S E R V I C E N O T E

8130A Programmable Pulse Generator**Serial Numbers:** 2905G00100 / 2905G00390**Reference Designator / Part Number / Assembly Name**

Solution to eliminate crosstalk to the output signal**To Be Performed By:** Agilent-Qualified Personnel**Parts Required:**

A1 Component Side, left upper corner

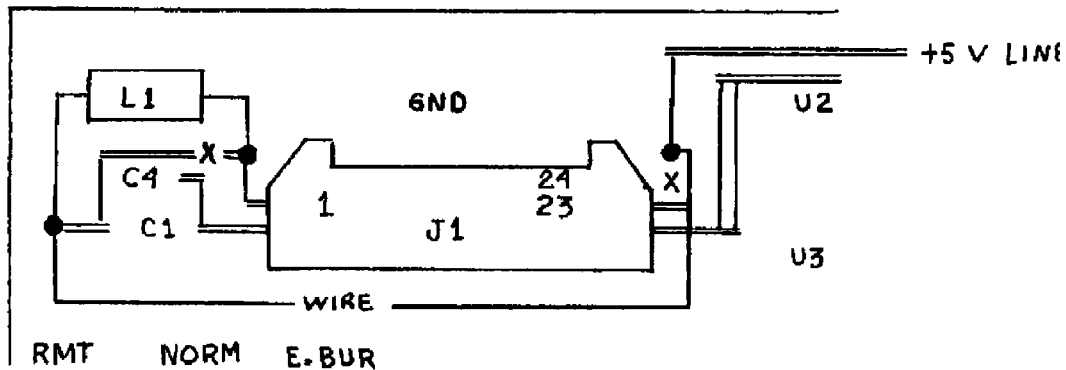
In the instruments with the serial numbers shown above, the display driver may influence the output signal. This results in spikes of about 10 mV.

To solve the problem the Key/Display Board has to be modified. Follow the instructions shown below.

Cut the +5 V line at the shown points (X)

Solder the WIRE and/or L1 to the shown points (●)
